Serial Nr.: 10/052,113
Art Unit: 2631

AMENDMENTS TO THE DRAWINGS:

REMARKS

FIG. 1
(PRIOR ART)

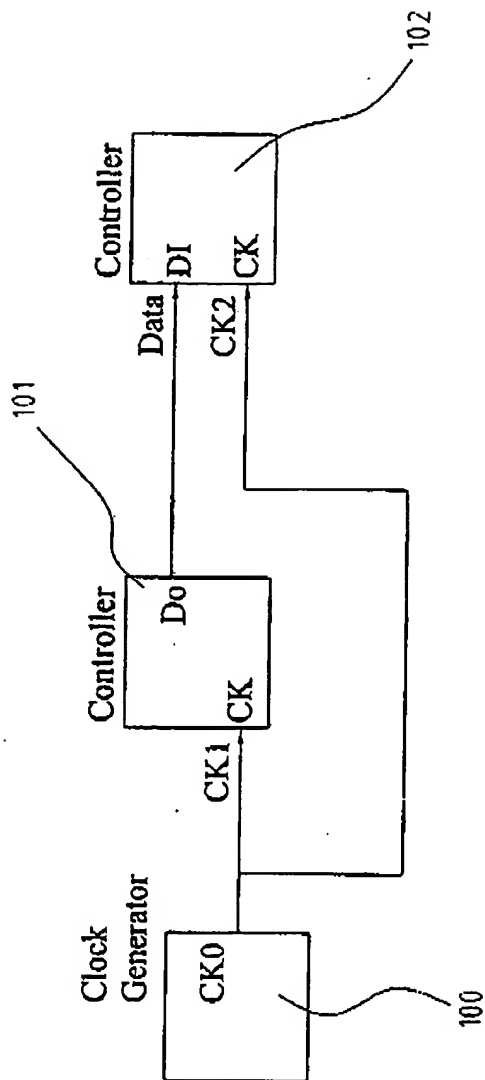
FIGs. 1 and 2 are amended to include a legend --Prior Art-- in each drawing. Annotated sheets showing marked-up changes for each drawing are submitted for approval.
